# "SIMPLE SOLUTIONS FOR '98"

## INTRODUCTION

***AUTOMATIC TRANSMISSION SERVICE GROUP***  
9200 S. DADELAND BLVD.  
SUITE 720  
MIAMI, FL 33156  
(305) 670-4161

Figure 6

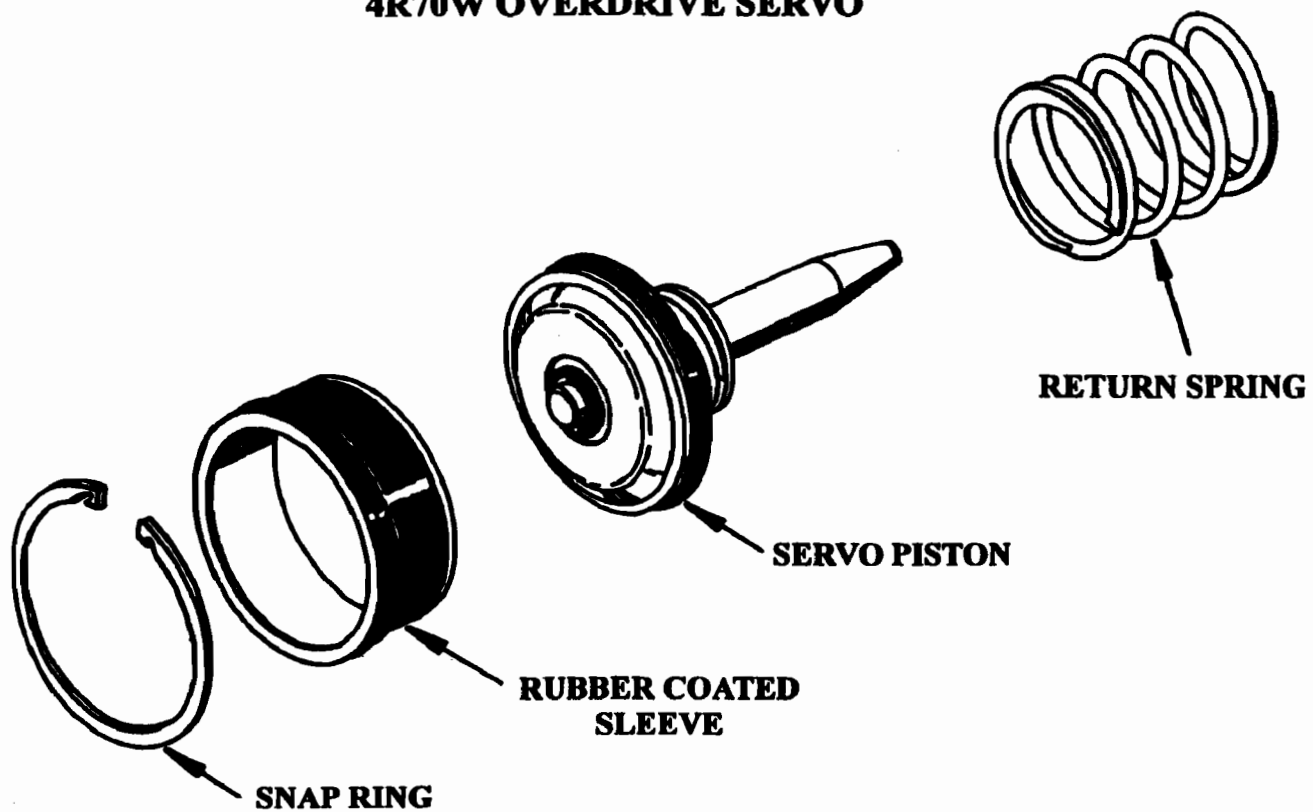
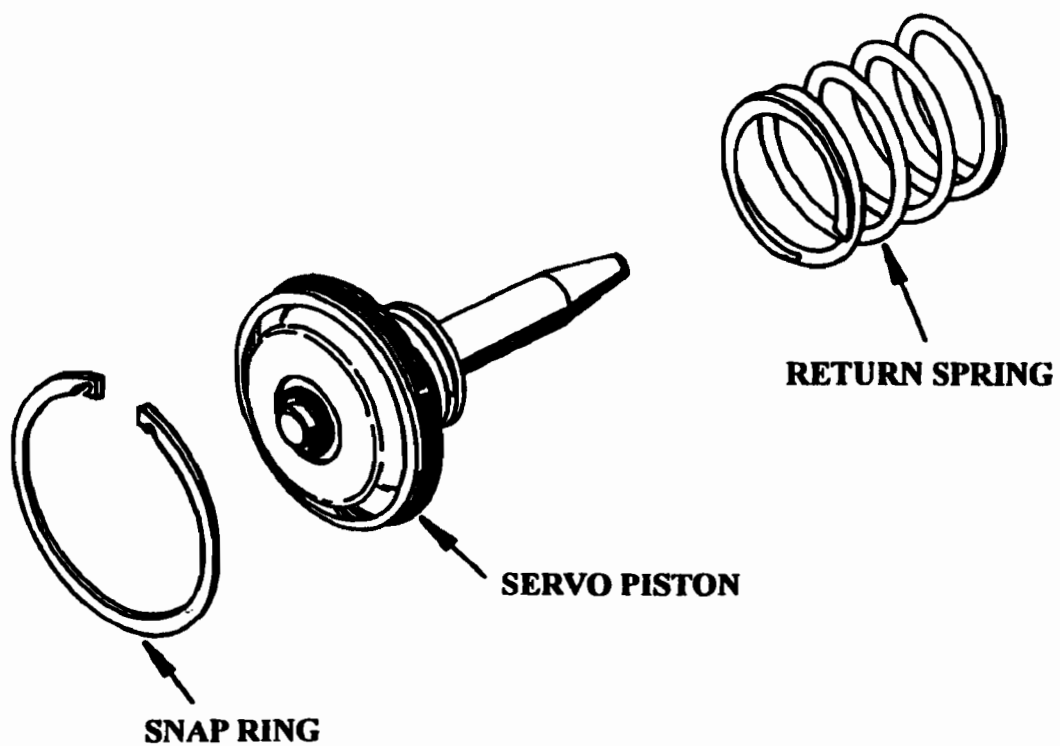
**CAUSE:** The cause may be a mis-assembled Overdrive Servo Assembly, with the "Rubber Coated Sleeve" omitted. The 4R70W transmission is calibrated with a smaller diameter overdrive servo piston than is the AOD-E transmission. To retain a common case between the two transmissions, an additional "Rubber Coated Sleeve" is required on the 4R70W Overdrive Servo Assembly, as shown in Figure 6.

**CORRECTION:** Install the "Rubber Coated Sleeve" in the Overdrive Servo Assembly, as shown in Figure 6. If your rubber coated sleeve is missing or lost, you **MUST** buy the complete Overdrive Servo Assembly, available under OEM part number F3LY-7H188-A. It is not available individually. Overdrive servo piston dimensions are shown in Figure 5, to identify the two different overdrive pistons.

Figure 1

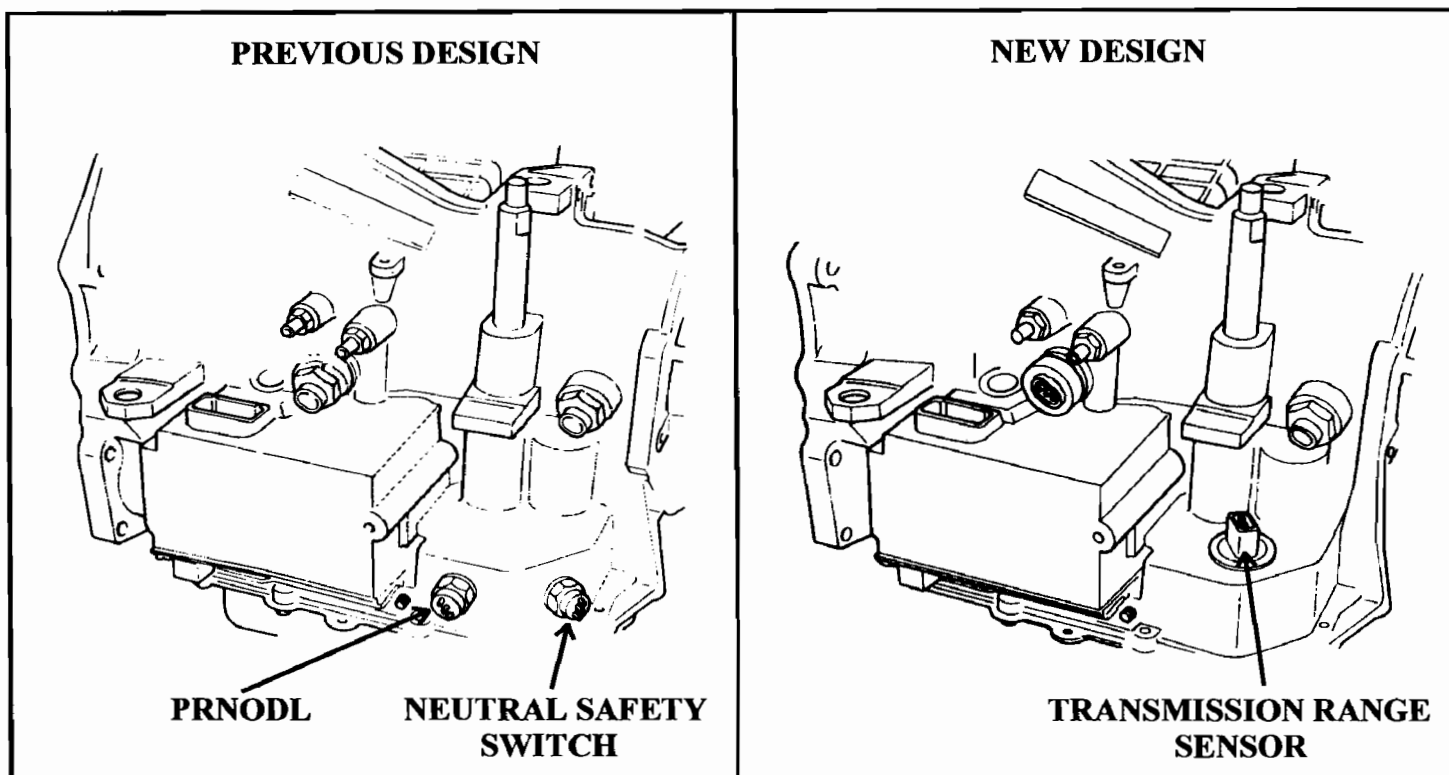
**CHANGE:** Beginning at the start of production 1996, some models equipped with the 41TE (A604) transaxle replaced the PRNODL and Neutral Safety Switch with a Transmission Range Sensor as seen in Figure 1.

- (1) PRNODL SWITCH - The previously used Park, Reverse, Neutral, Overdrive, Drive, Low Switch (PRNODL) has been eliminated and replaced with the new Transmission Range Sensor (See Figure 1).

- (2) NEUTRAL SWITCH - The previously used Neutral Switch has been eliminated and replaced with the new Transmission Range Sensor (See Figure 1).
- (3) TRANSAXLE CASE - The casting of the case change with the elimination of the two threaded holes for the PRNODL and Neutral Safety Switch. An access hole has been added to accommodate the new TRS sensor connector as the switch which is mounted on the valve body (See Figure 1).

Figure 2

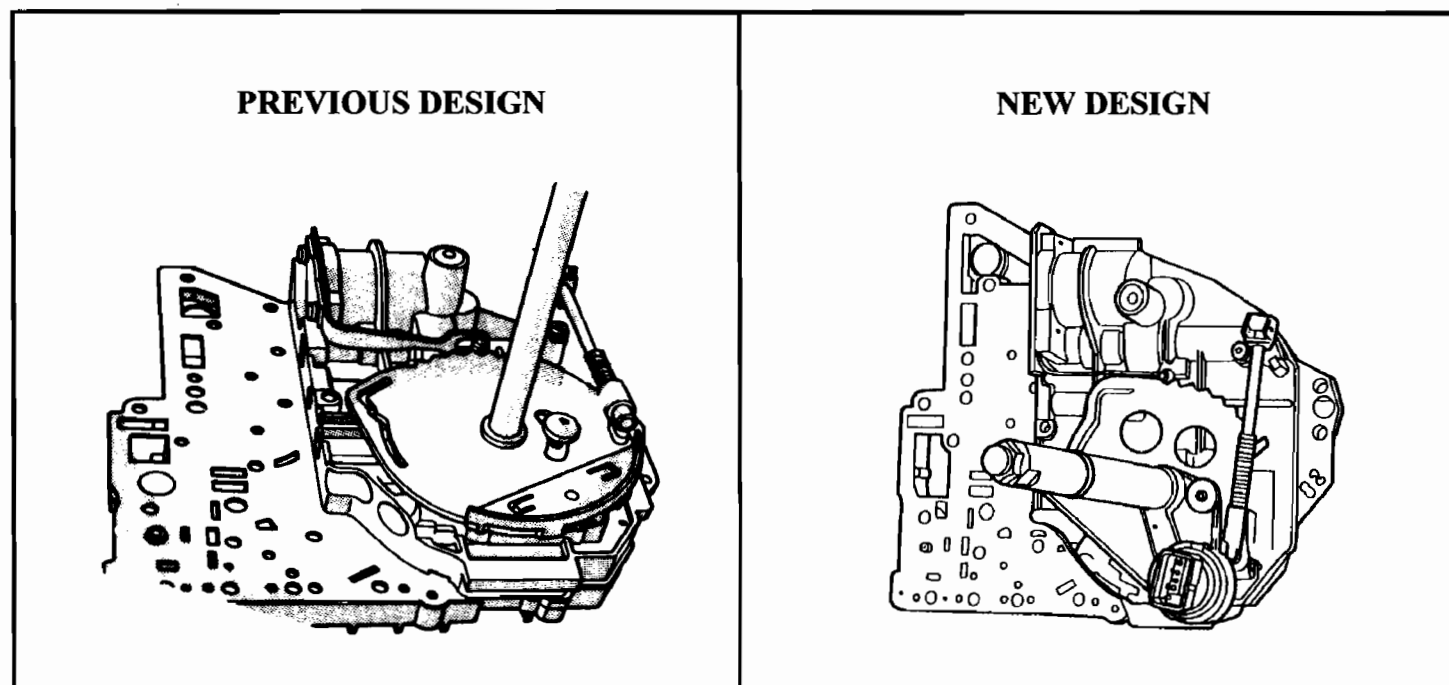
- (4) VALVE BODY - The manual arm shaft and rooster comb assembly and the valve body changed in design to accommodate the mounting of the new TRS sensor (See Figure 2).

Figure 1

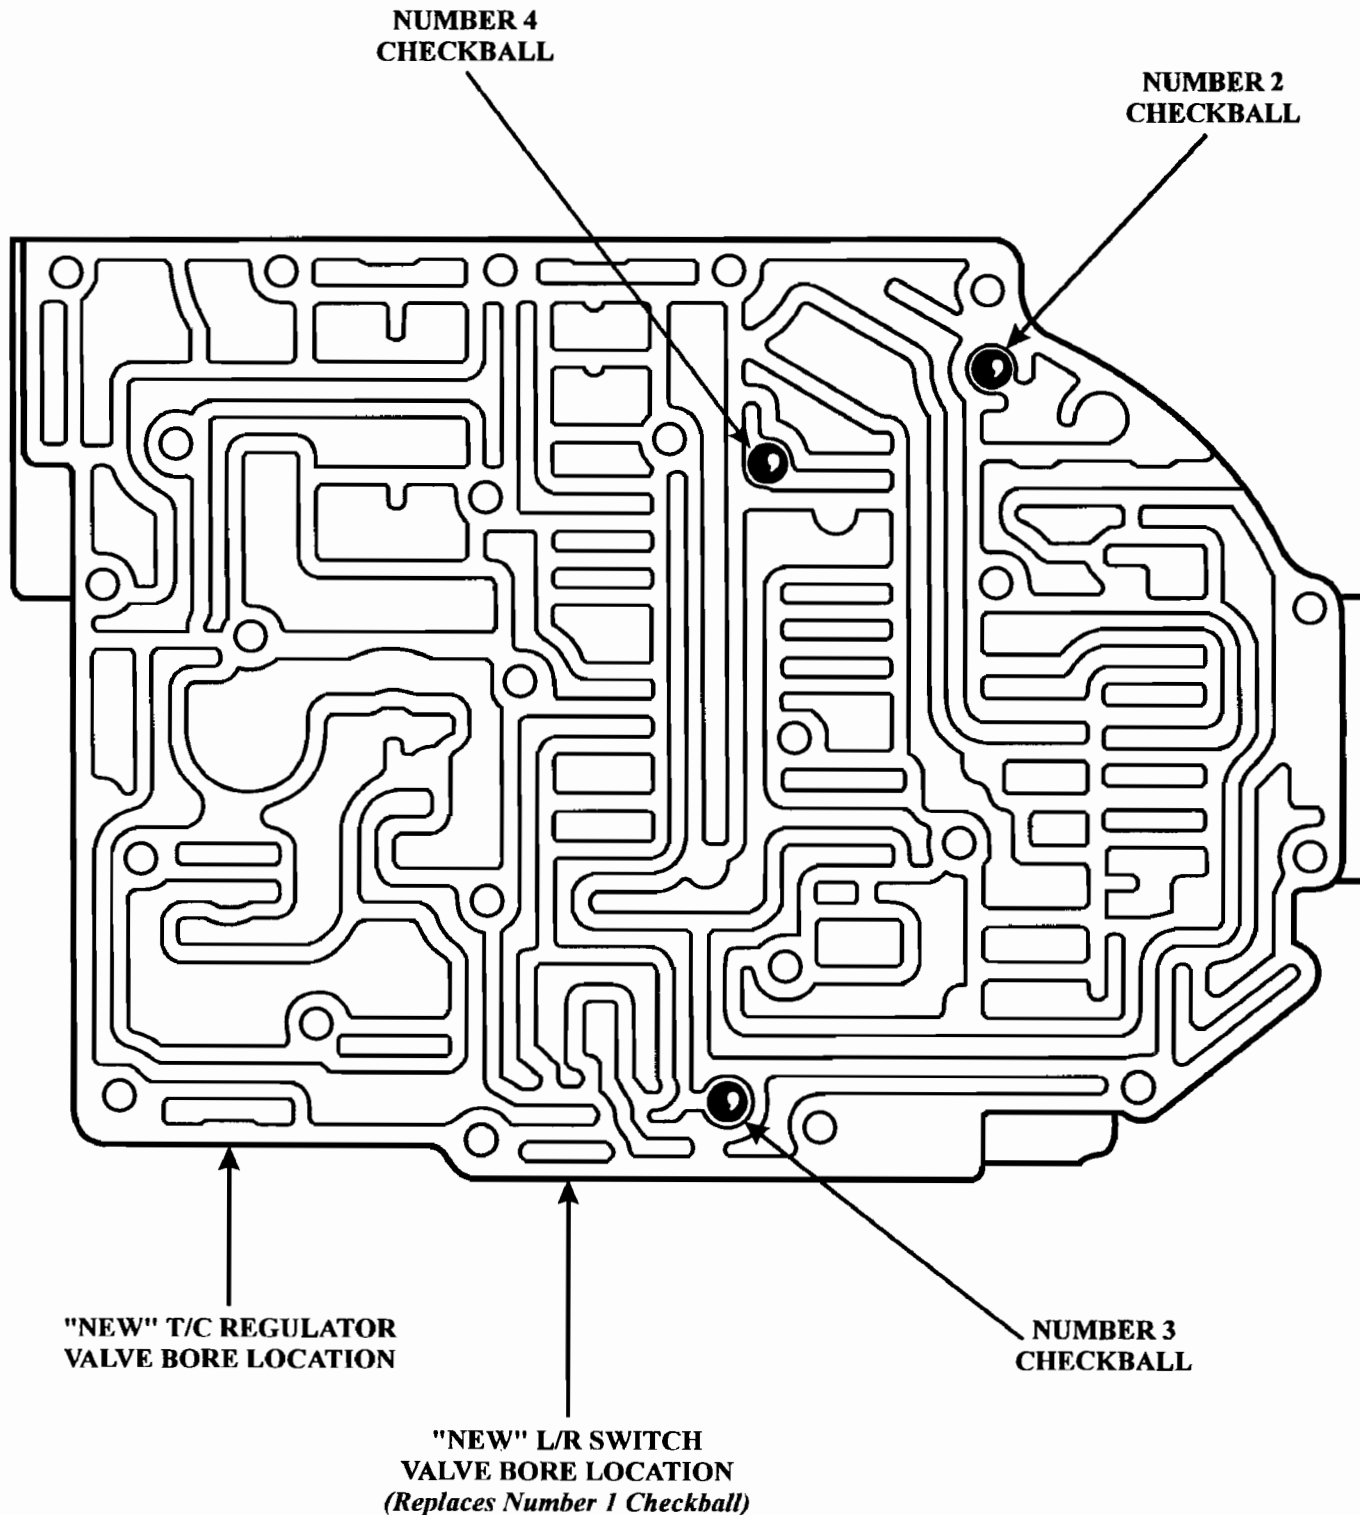
- (1) **VALVE BODY** - New valve body casting with the Number 1 checkball eliminated, as shown in Figure 1. Two new valves were added to the valve body, first was a L/R Switch Valve to serve the same function as the number 1 checkball, and second was a T/C Regulator Valve to limit converter clutch apply pressure to a maximum of 95 PSI. Refer to Figure 1 for the locations of these new valves and the new checkball locations.
- (2) **TRANSFER PLATE** - New transfer plate casting to accommodate the changes in the new design valve body. Refer to Figure 2 for the new transfer plate.
- (3) **SPACER PLATE** - New spacer plate stamping to accommodate the changes in the new valve body, as shown in Figure 3.

Figure 3

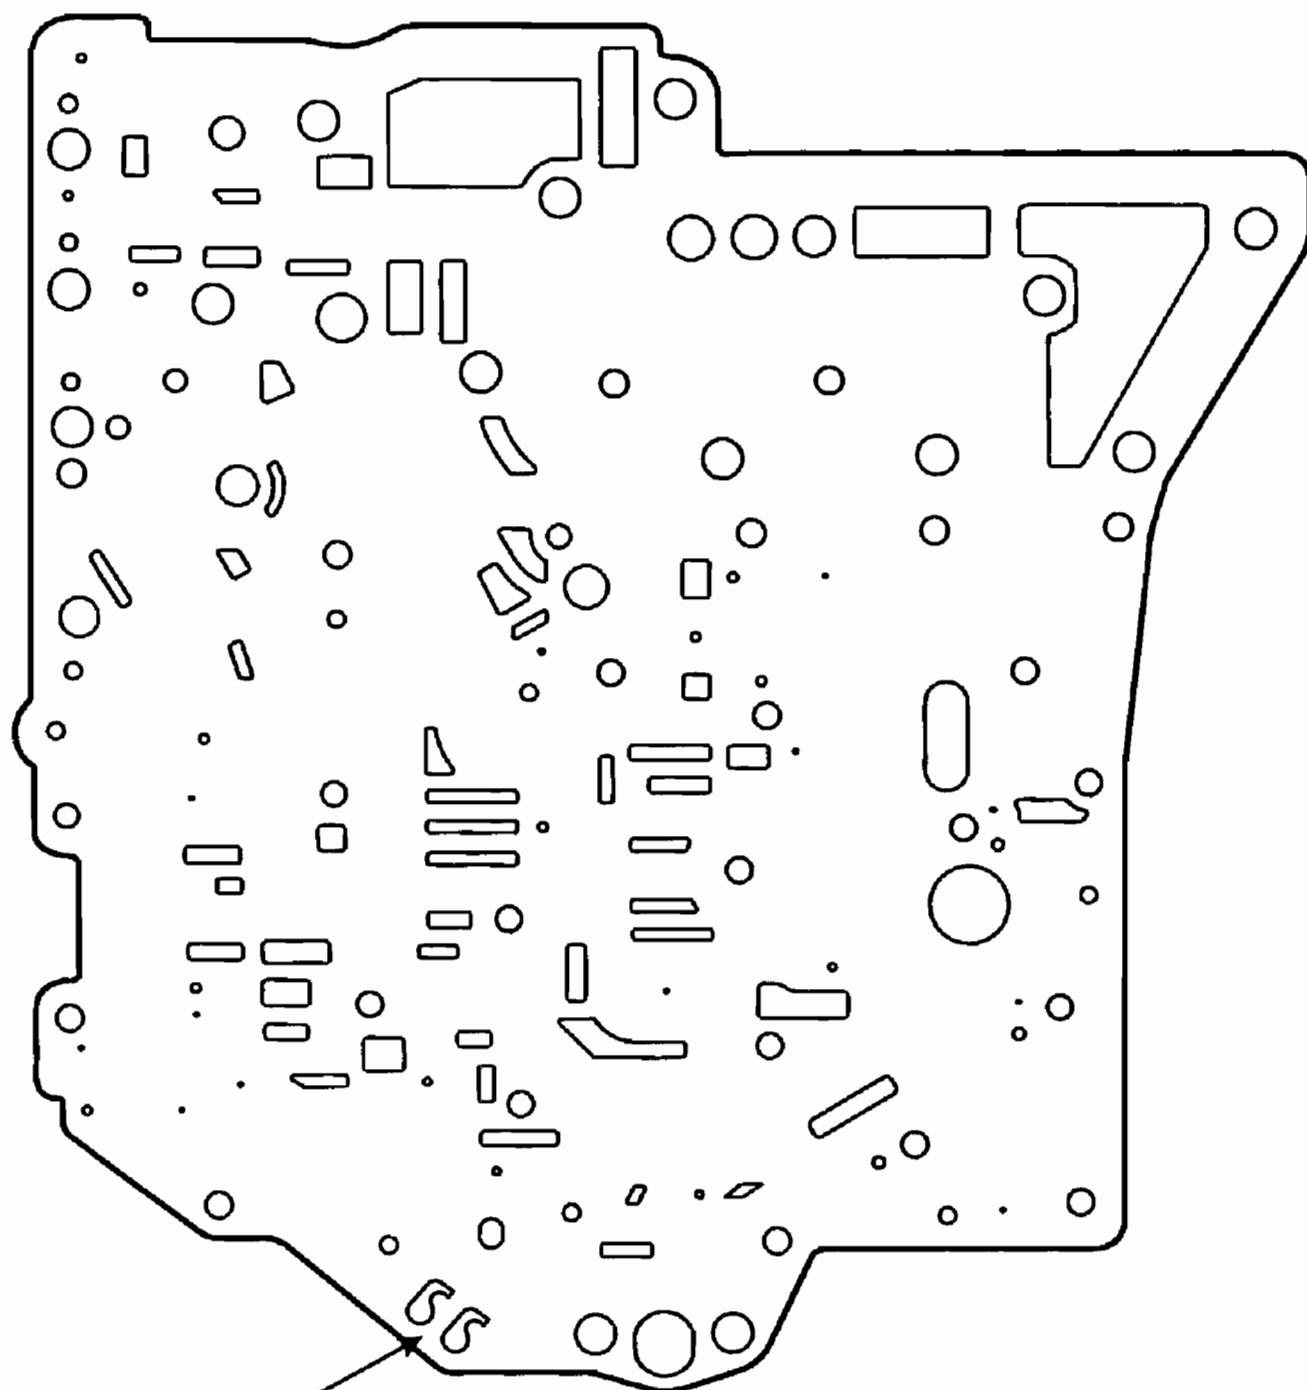
Number stamped for identification into new spacer plate is "66" (See Figure 3).

Figure 2

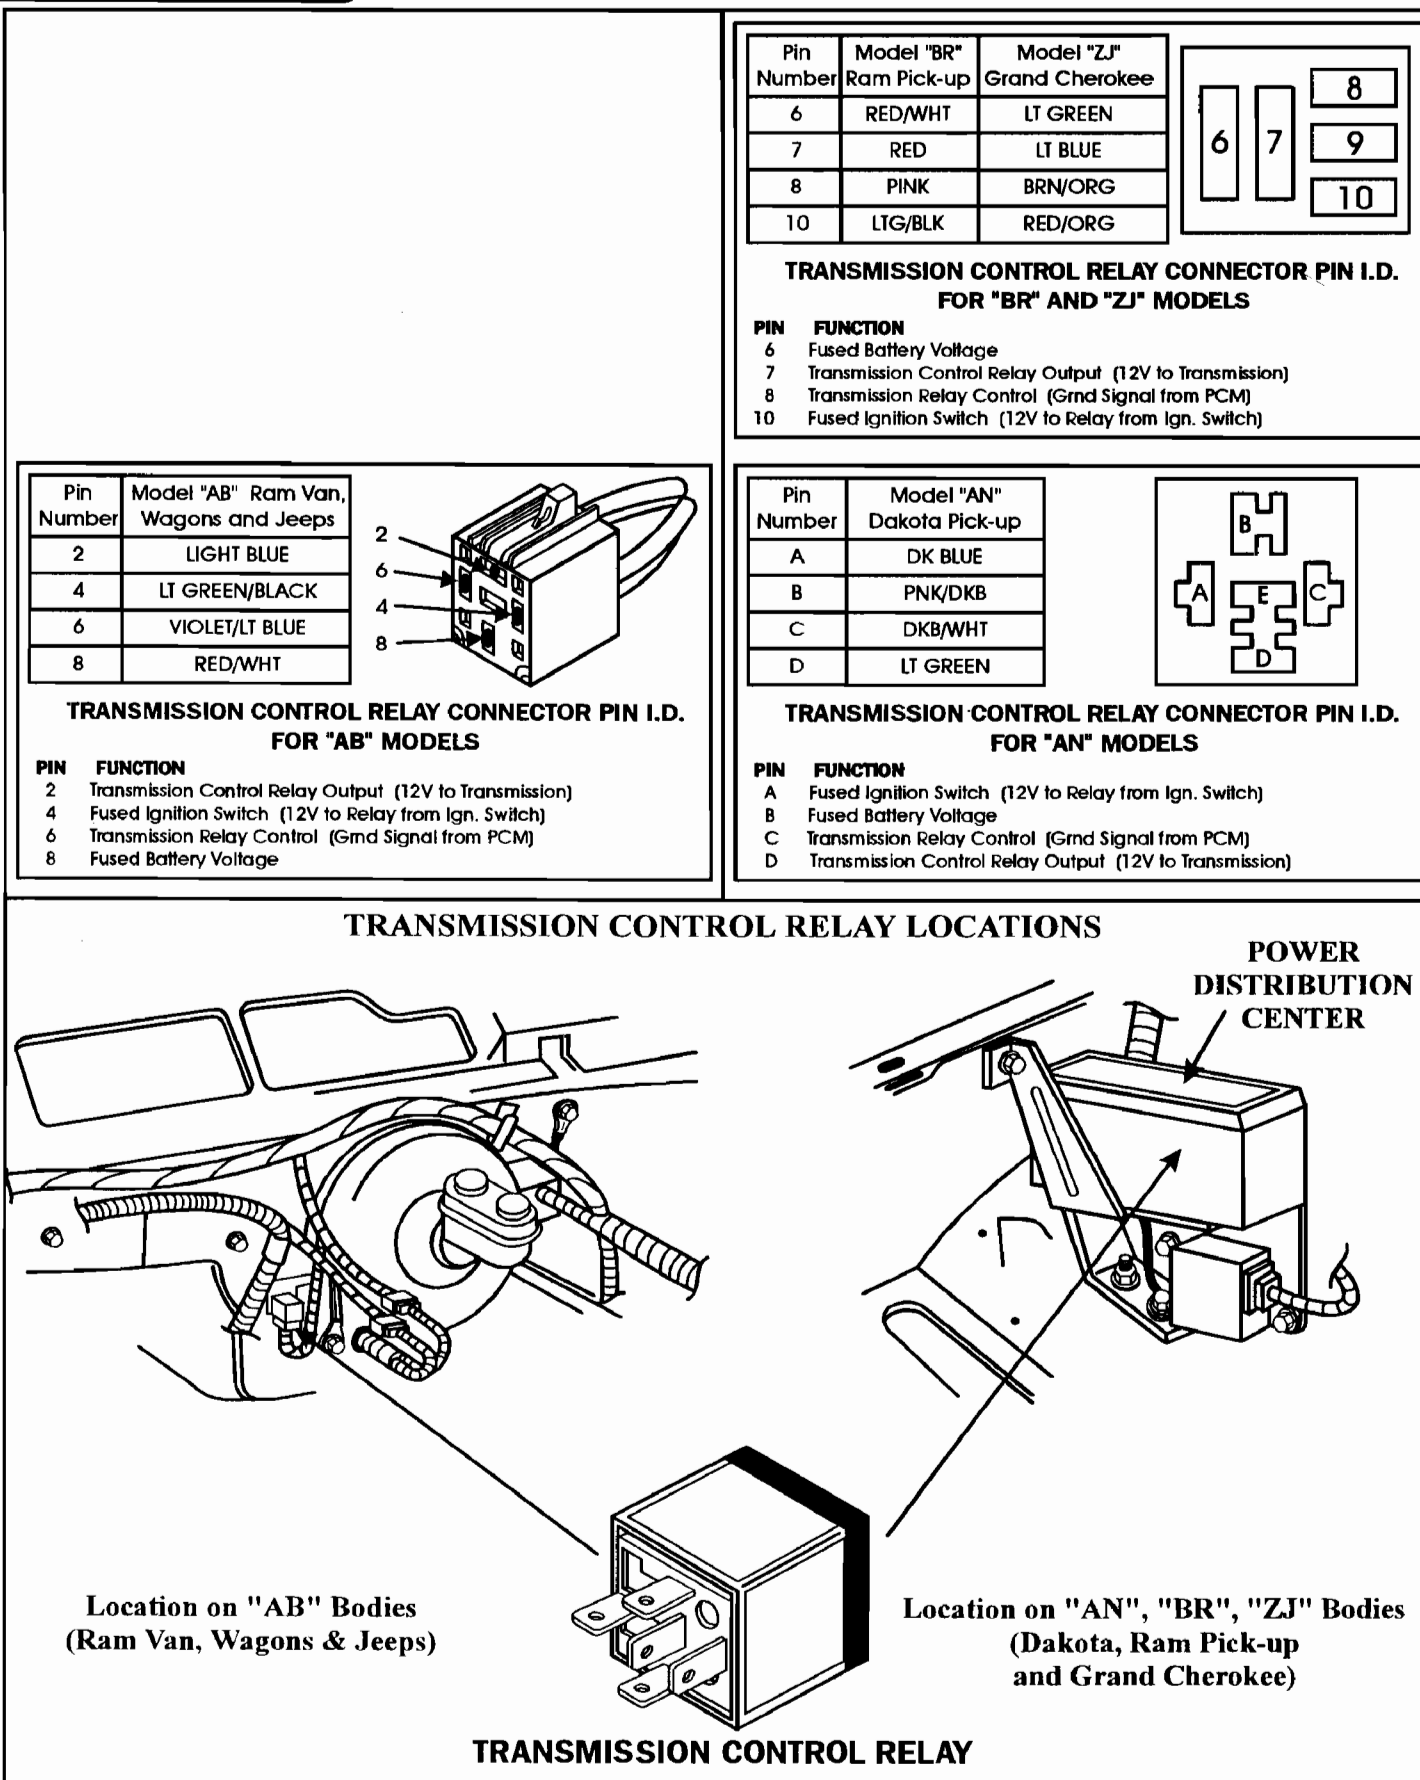
- (1) GOVERNOR PRESSURE SENSOR - Now incorporates the Transmission Fluid Temperature Sensor which requires four terminals on the sensor instead of the previous three, as shown in Figure 1.
- (2) INTERNAL WIRING HARNESS - Eliminates the previous TFT from the solenoid assembly and requires a new connector with four wires to accommodate the new design Governor Pressure Sensor. Refer to Figure 1.
- (3) TRANSMISSION CONTROL MODULE - Eliminated, and transmission functions are now handled by the Powertrain Control Module (PCM).
- (4) TRANSMISSION CONTROL RELAY - Added to control the voltage to pin number one at the transmission and controlled with a ground signal from the PCM. Refer to Figure 2 for the locations and wire colors on the various models, and Figure 3 for a complete wire schematic.
